March 10, 2015
BOARD OF COUNTY COMMISSIONERS
ORANGE COUNTY, FLORIDA
Addendum No. 1/IFB Y15-750-CH

INTERNATIONAL DRIVE IMPROVEMENT PROJECT (FROM WESTWOOD BLVD.
SOUTH TO WESTWOOD BLVD. NORTH)

PLAN AND PROFILE
 INTERNATIONAL DRIVE
 STA 44+20 TO STA 49+80

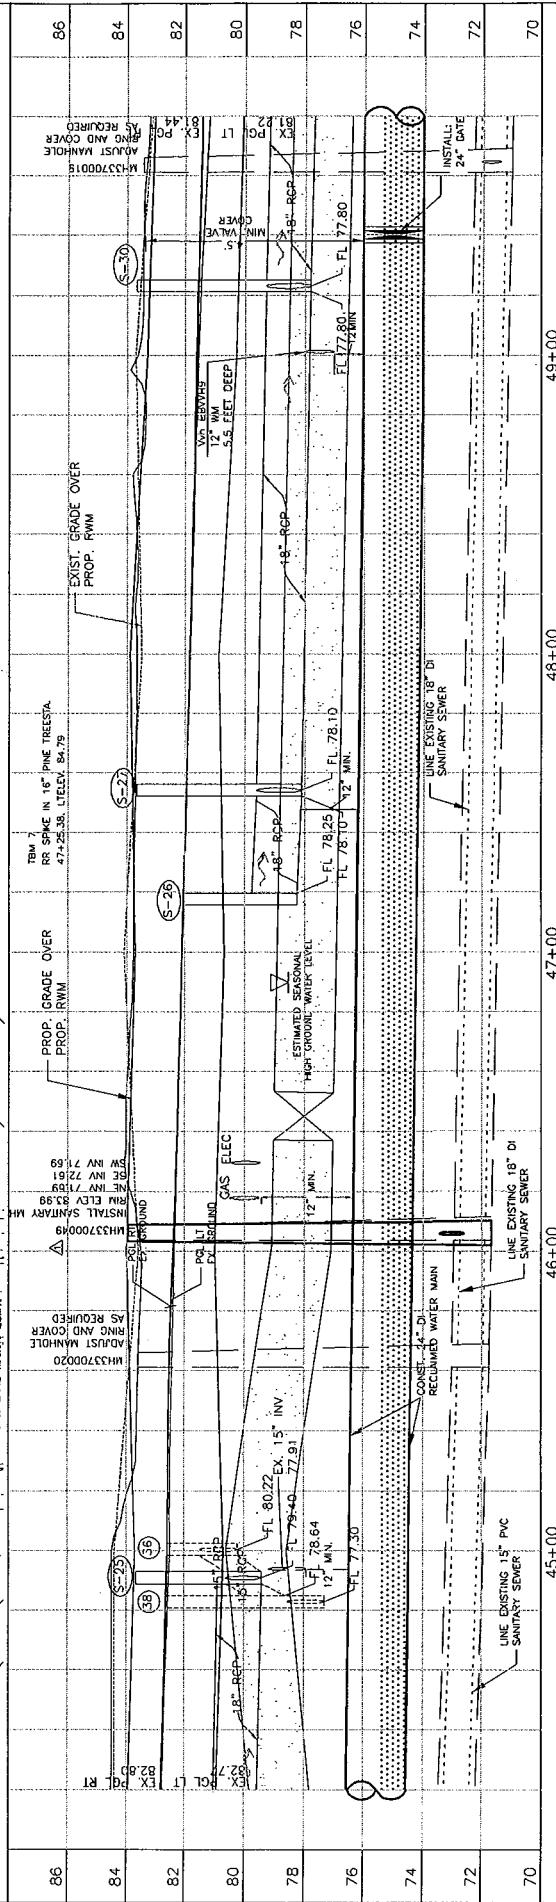
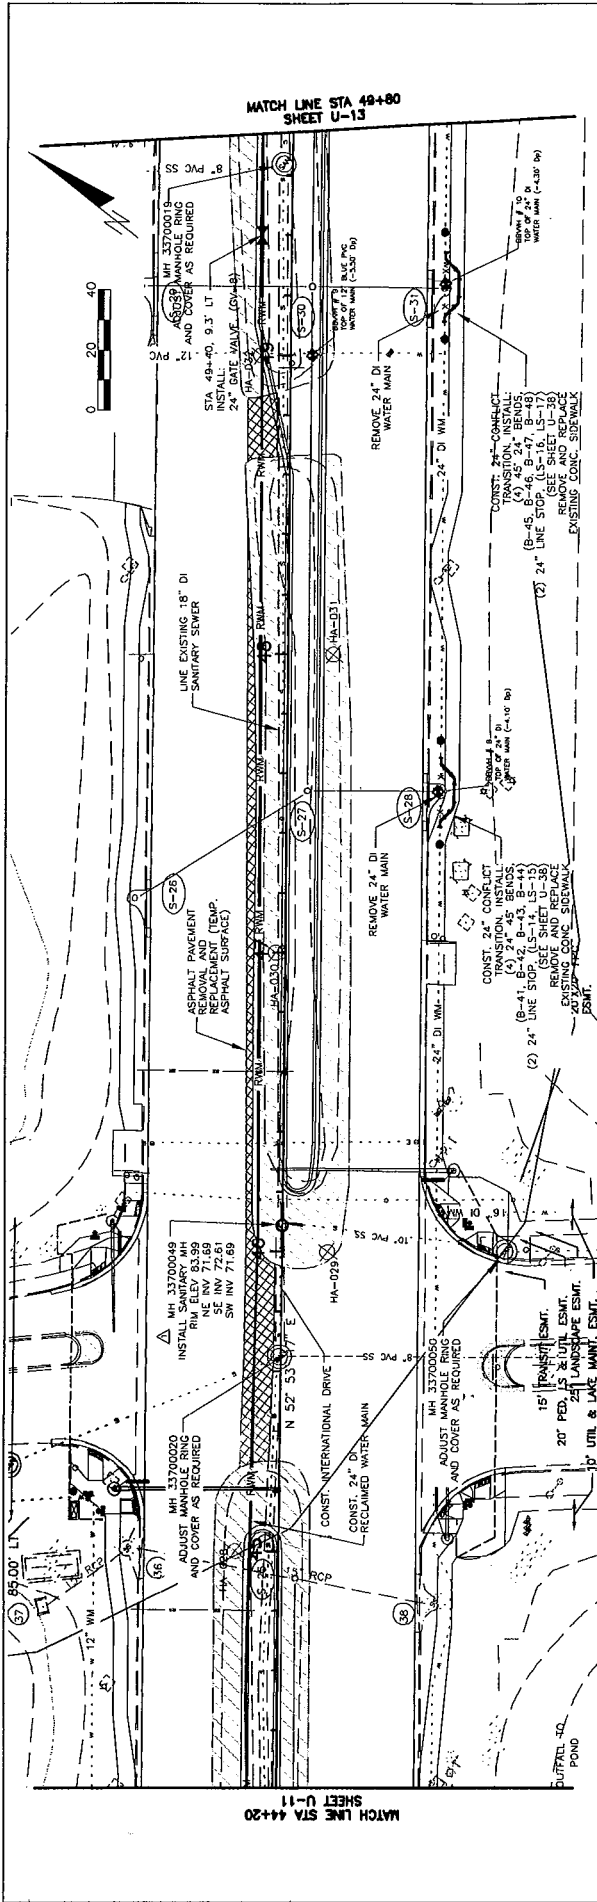
8. Note the **REVISION** to the Utilities Construction Plan Sheet as follow:

Sheet U-12 has been revised to depict the replacement of Manhole 33700049 (at Station $\pm 46+10$). An excerpt of the modification is provided herein (see attached, partial sheet)
